SPECIAL PROVISIONS

SEVENTH AVENUE BRIDGE  
OVER THE  
ARIZONA CANAL DIVERSION CHANNEL

CONTRACT NO. FCD 87-53

FLOOD CONTROL DISTRICT OF MARICOPA COUNTY  
CONTRACT FCD 87-53

Exhibit A

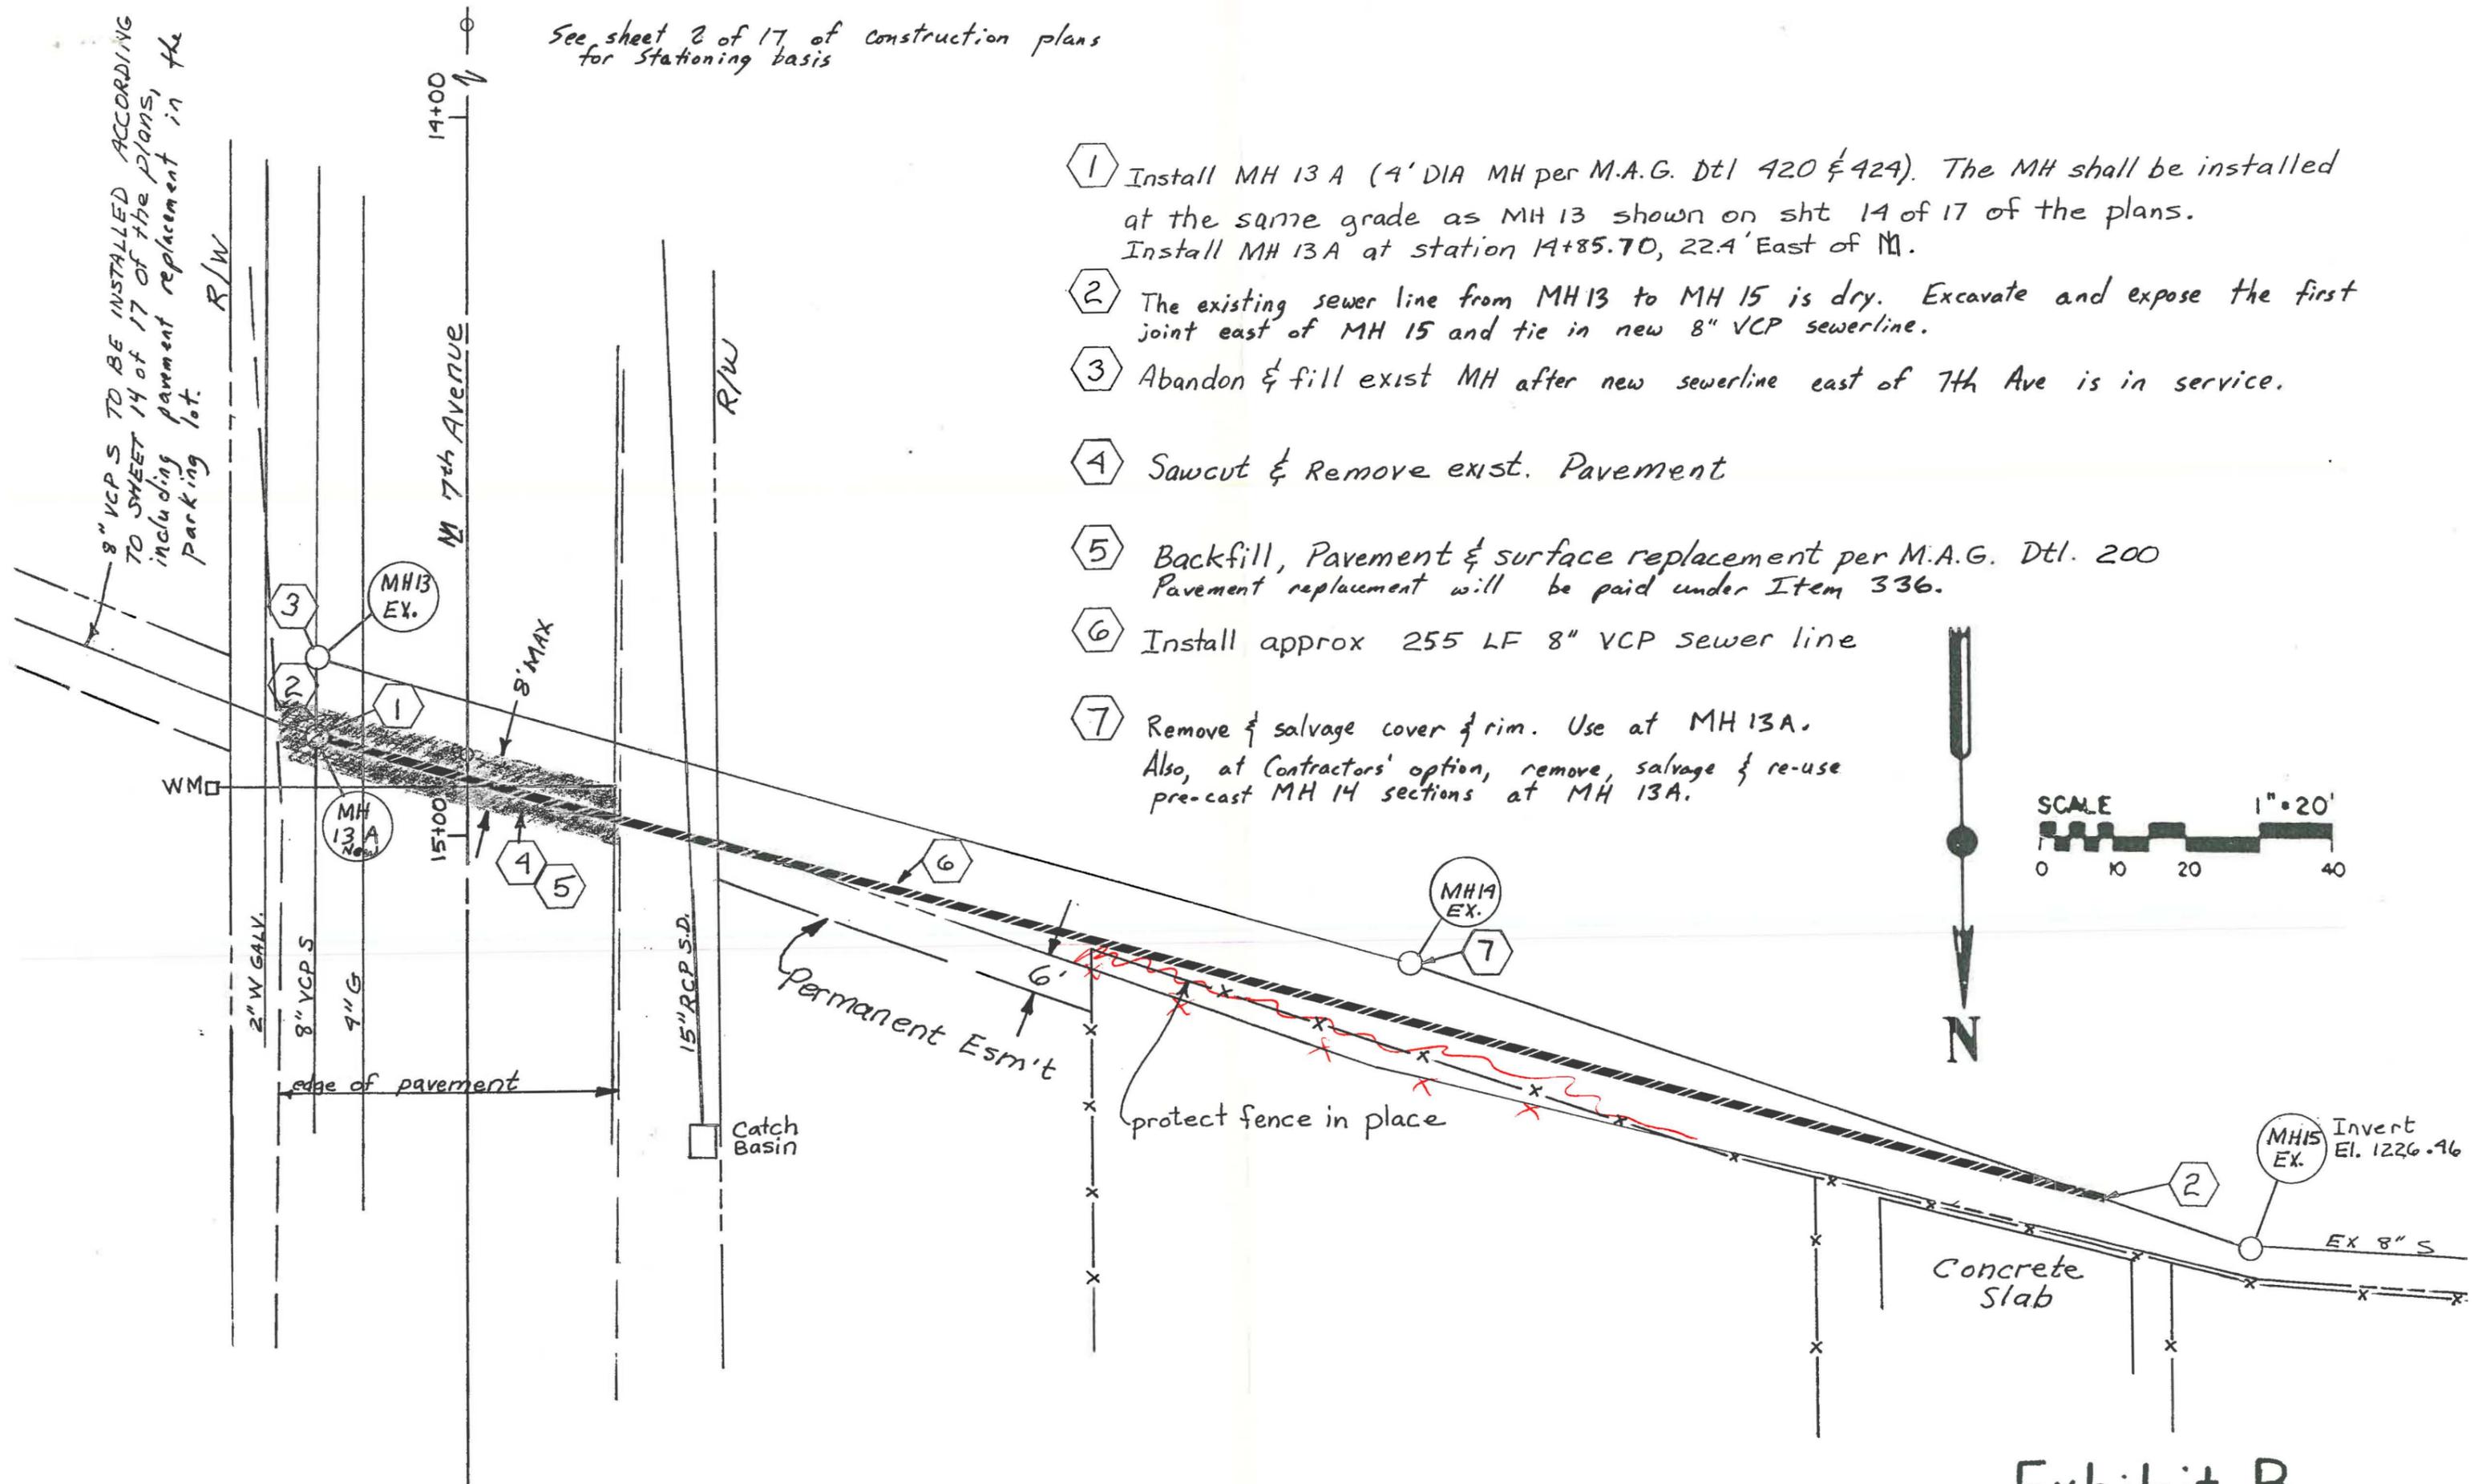
Install new sewerline and pavement replacement to east property line. See sheet 14 of 17 of the construction plans. Pavement replacement paid under Item 336

C 3/4" Asphaltic Concrete over 4" of compacted ABC. Approximate dimensions of paved area are 100' x 36'; plus 6' x 25' area adjacent to sidewalk.

Exhibit B

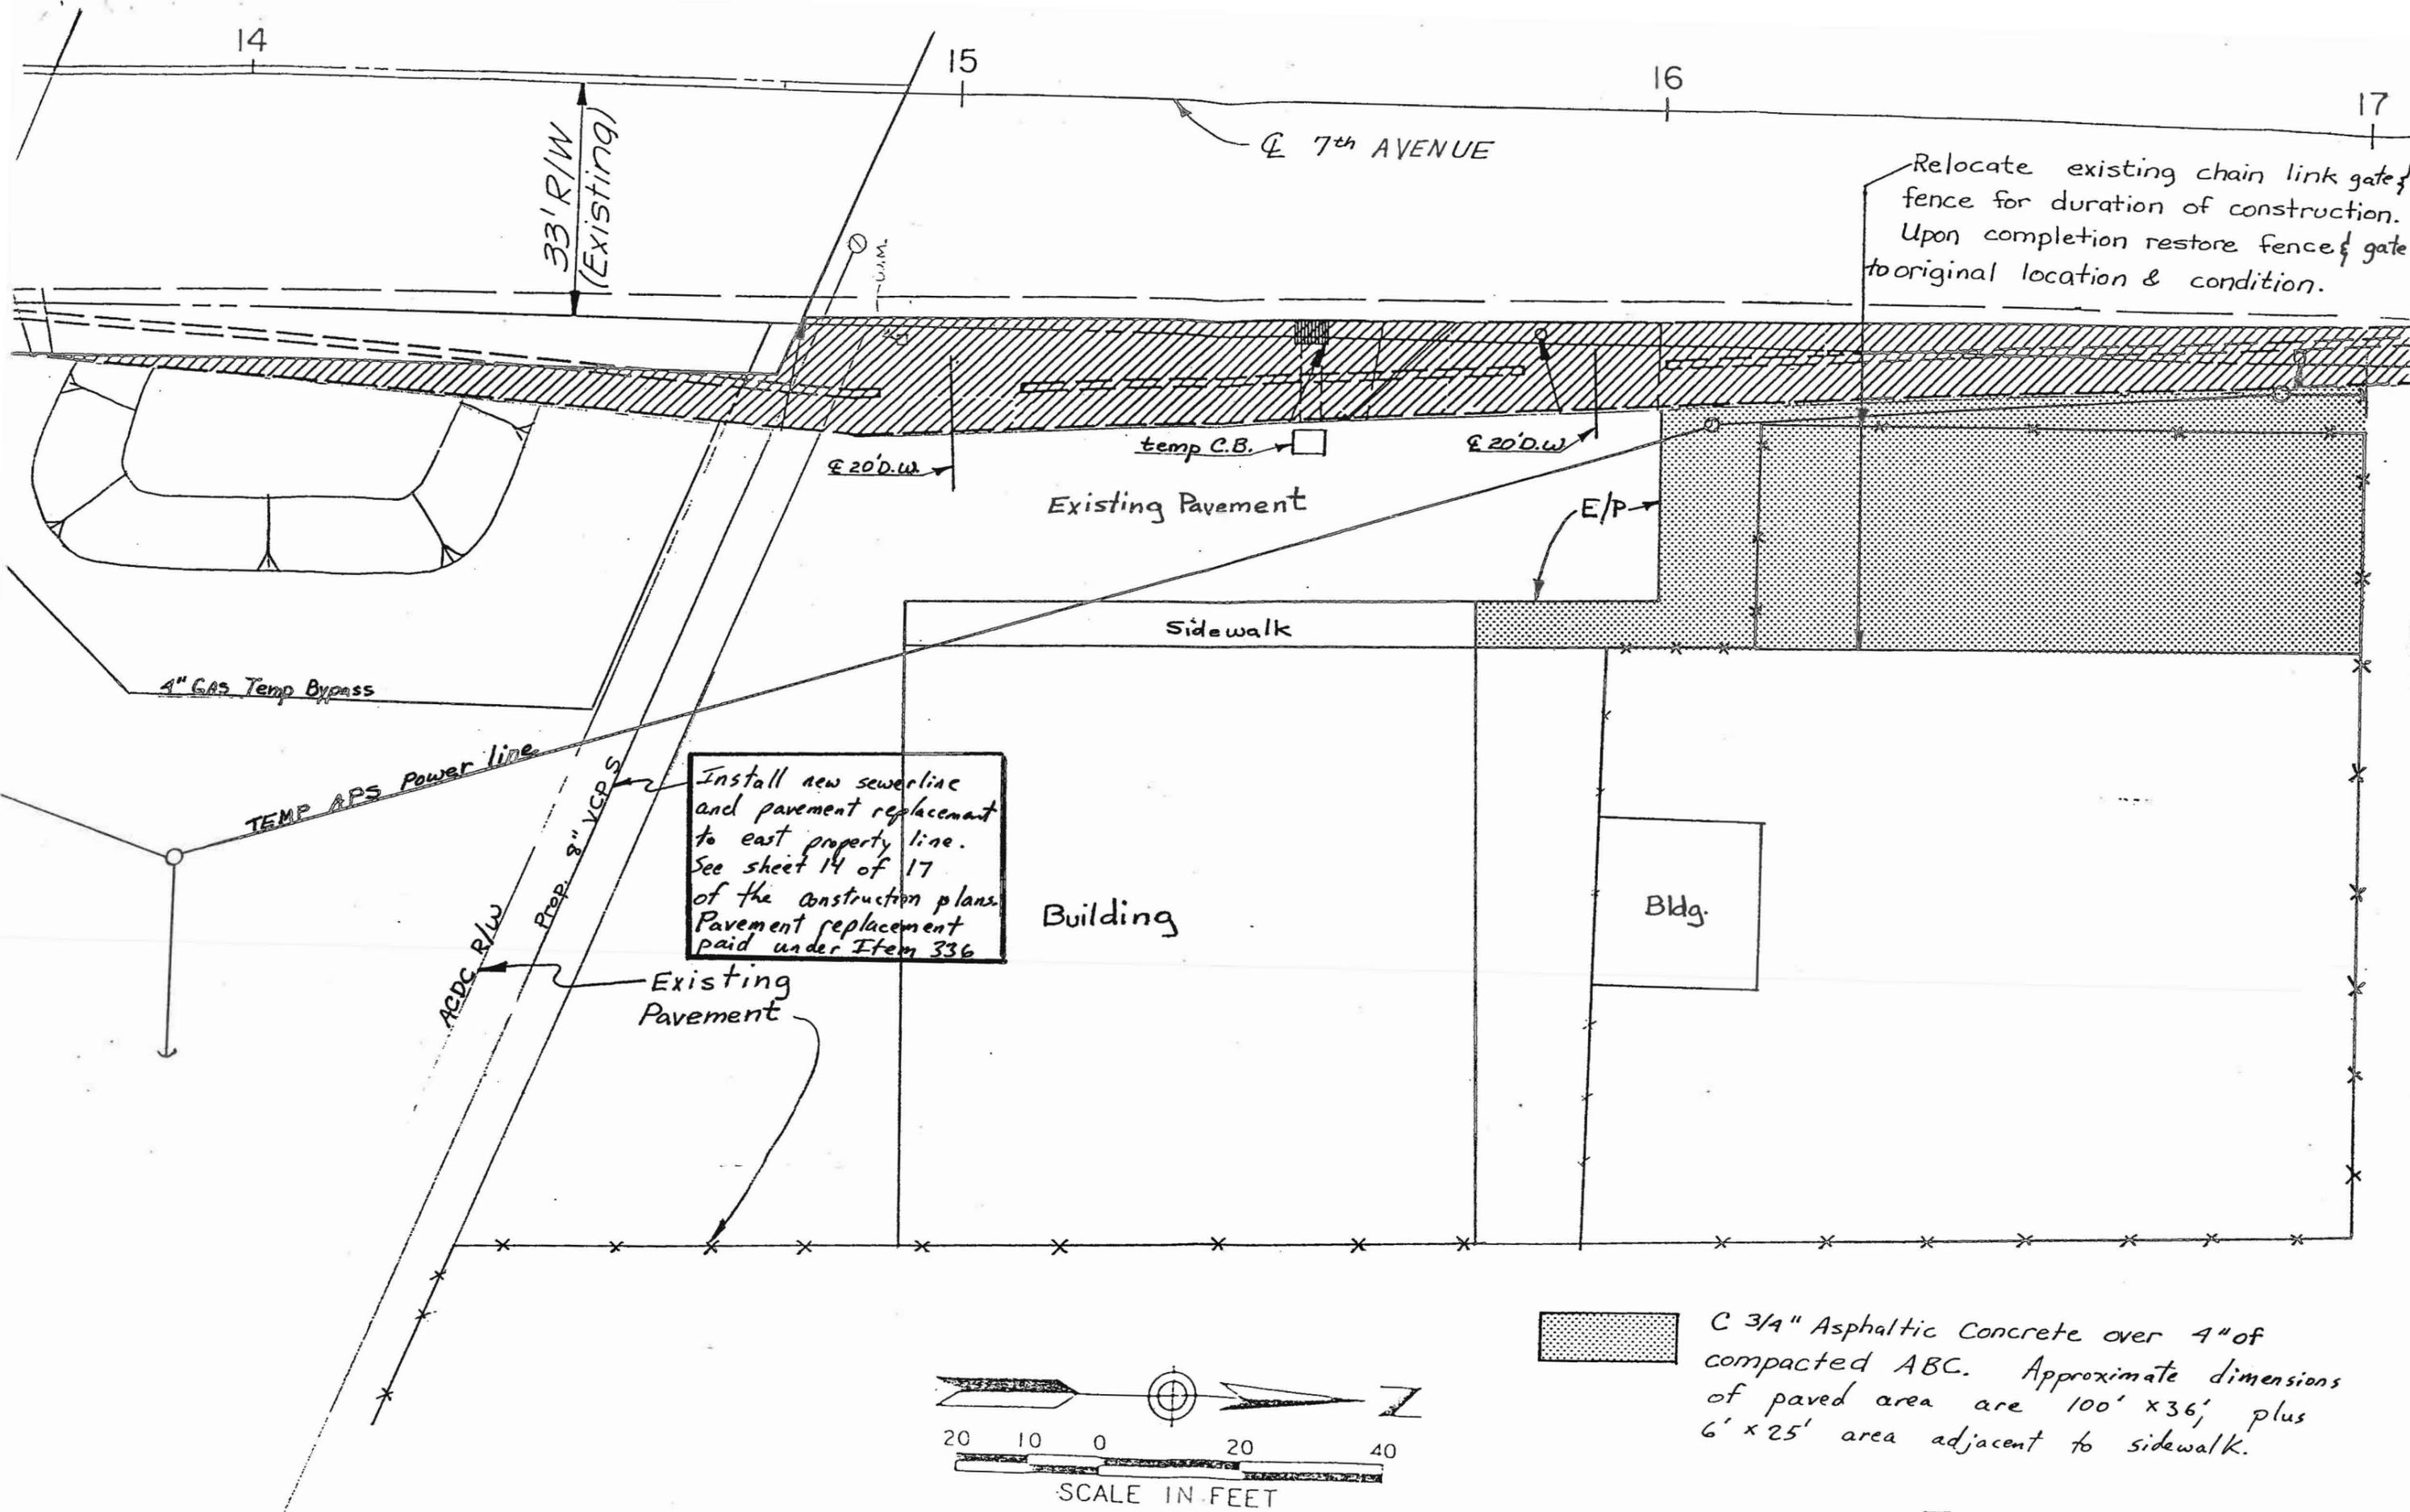
See sheet 2 of 17 of construction plans for Stationing basis

- ① Install MH 13 A (4' DIA MH per M.A.G. Dtl 420 & 424). The MH shall be installed at the same grade as MH 13 shown on sht 14 of 17 of the plans. Install MH 13 A at station 14+85.70, 22.4' East of M.
- ② The existing sewer line from MH 13 to MH 15 is dry. Excavate and expose the first joint east of MH 15 and tie in new 8" VCP sewerline.
- ③ Abandon & fill exist MH after new sewerline east of 7th Ave is in service.
- ④ Sawcut & Remove exist. Pavement
- ⑤ Backfill, Pavement & surface replacement per M.A.G. Dtl. 200. Pavement replacement will be paid under Item 336.
- ⑥ Install approx 255 LF 8" VCP sewer line
- ⑦ Remove & salvage cover & rim. Use at MH 13A. Also, at Contractors' option, remove, salvage & re-use pre-cast MH 14 sections at MH 13A.

Exhibit A

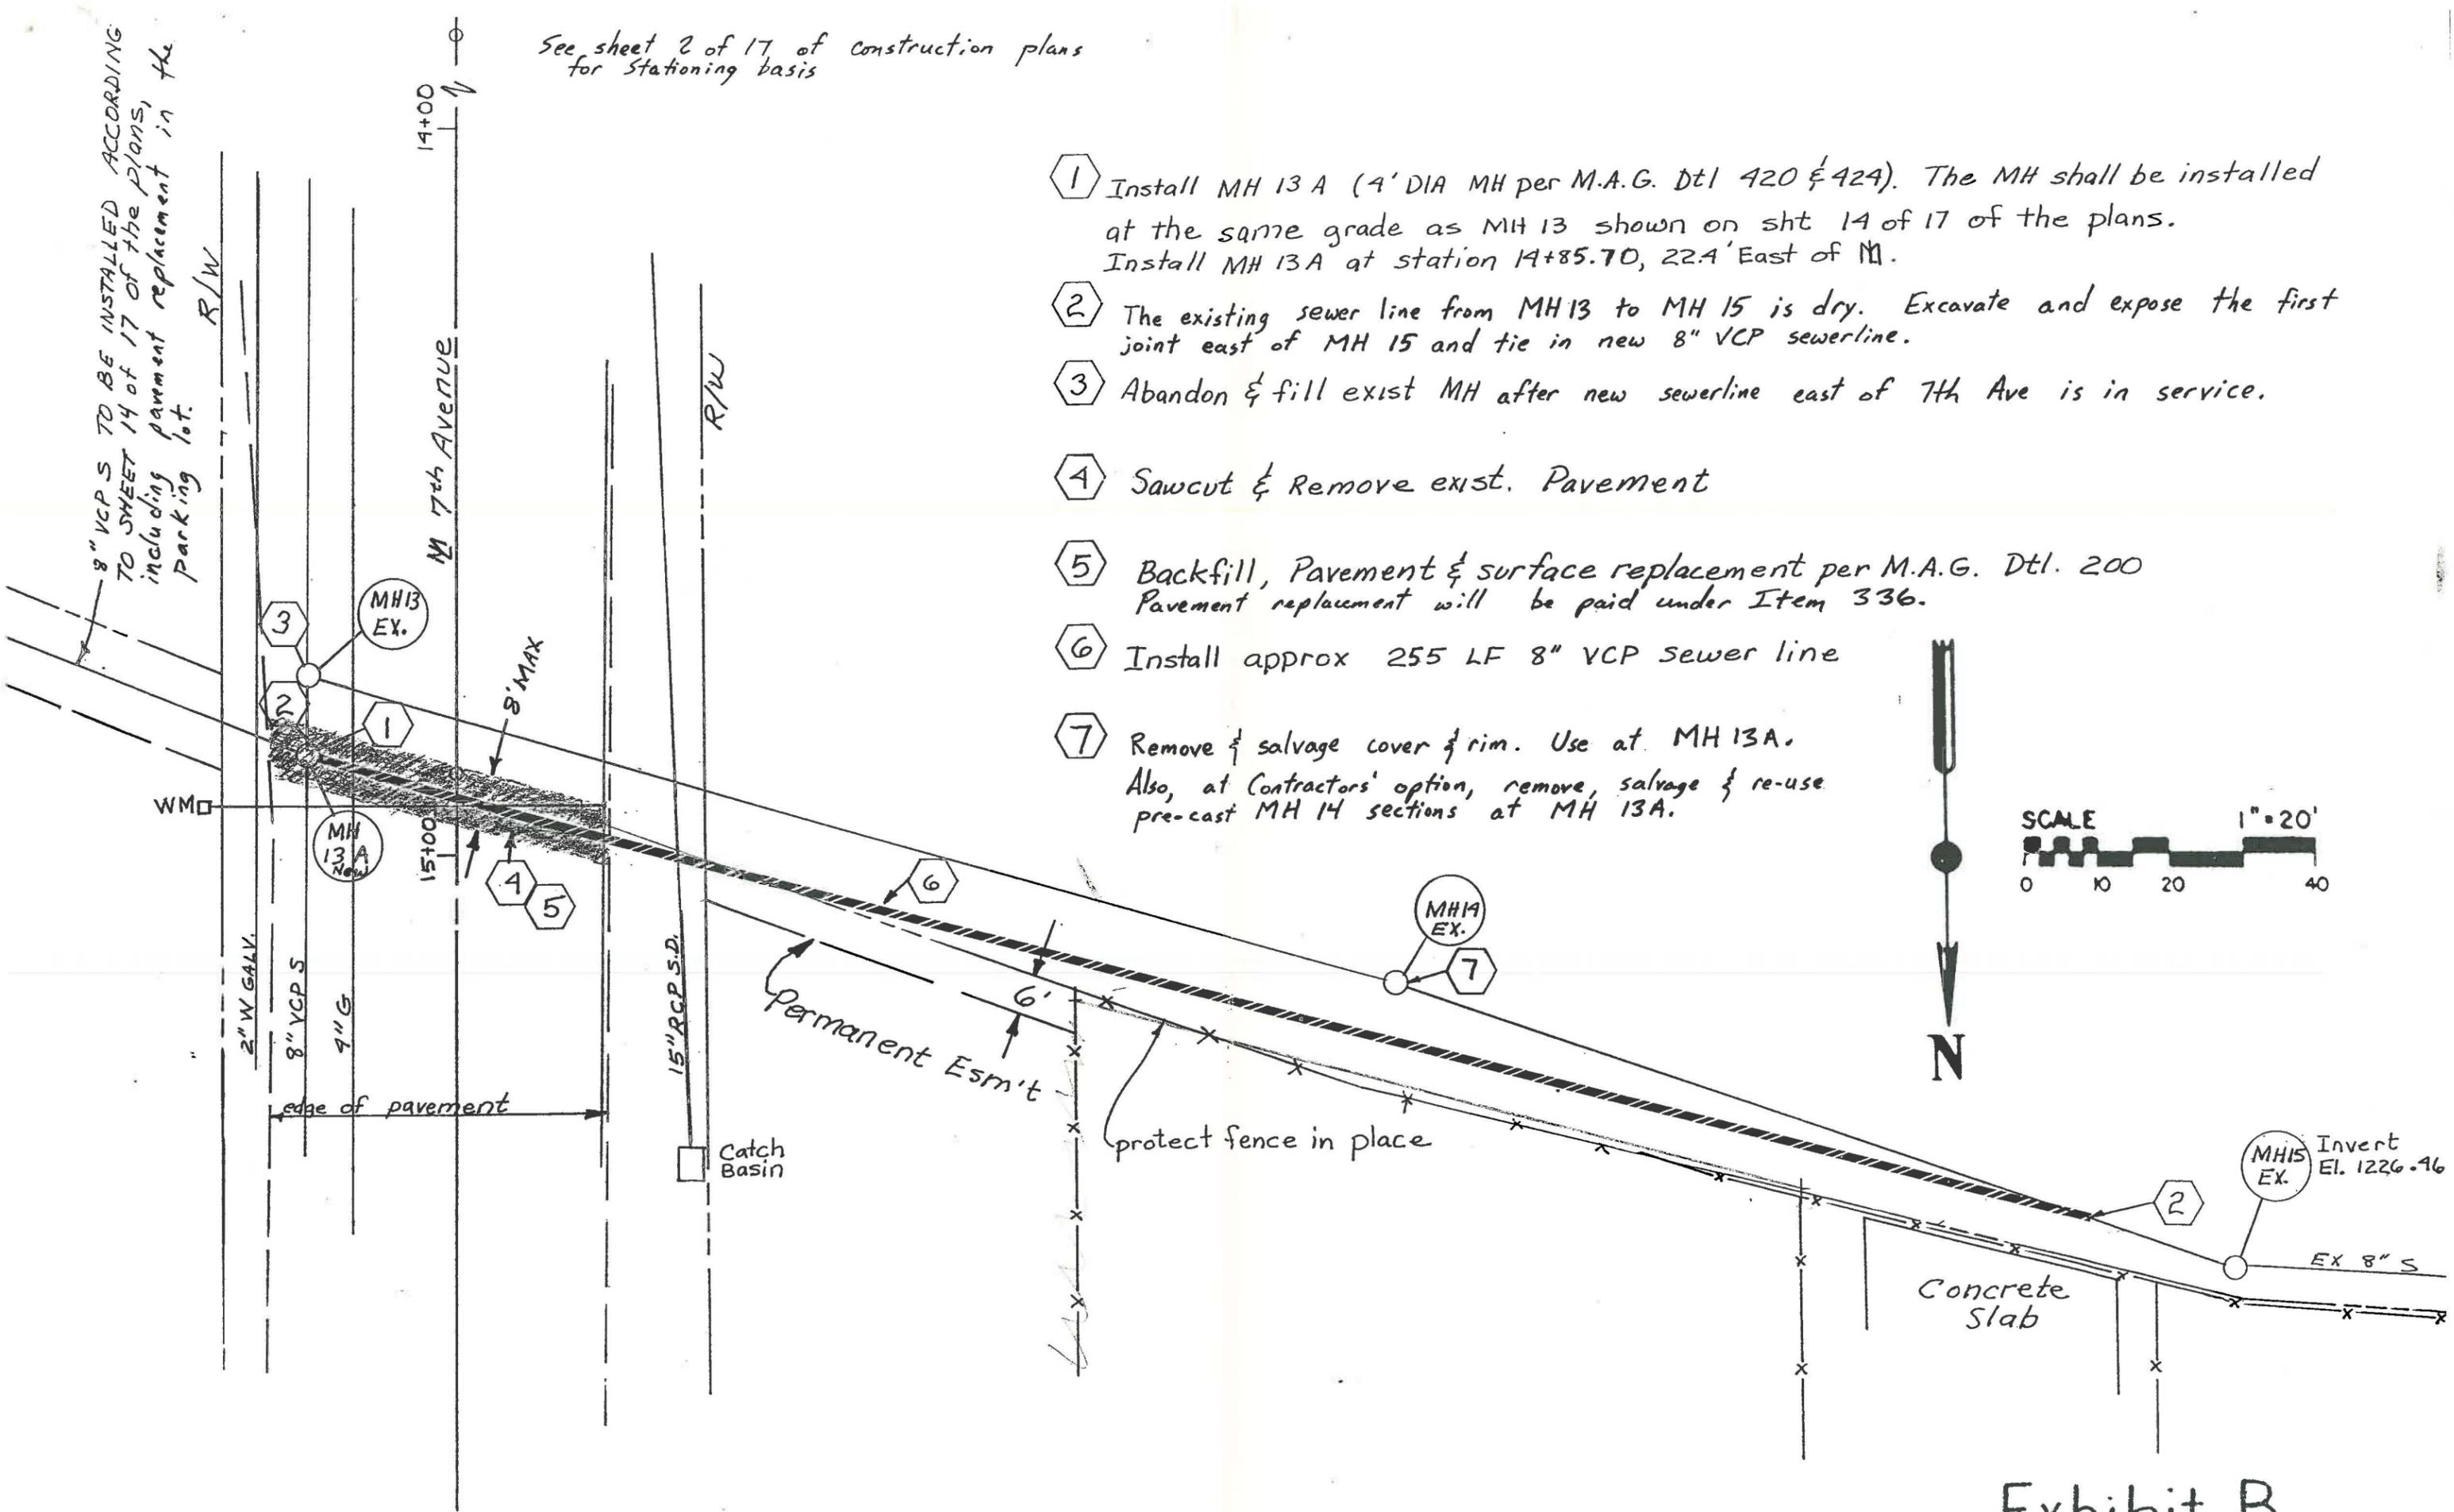
See sheet 2 of 17 of construction plans for Stationing basis

8" VCP S TO BE INSTALLED ACCORDING TO SHEET 14 of 17 of the plans, including pavement replacement in the parking lot.
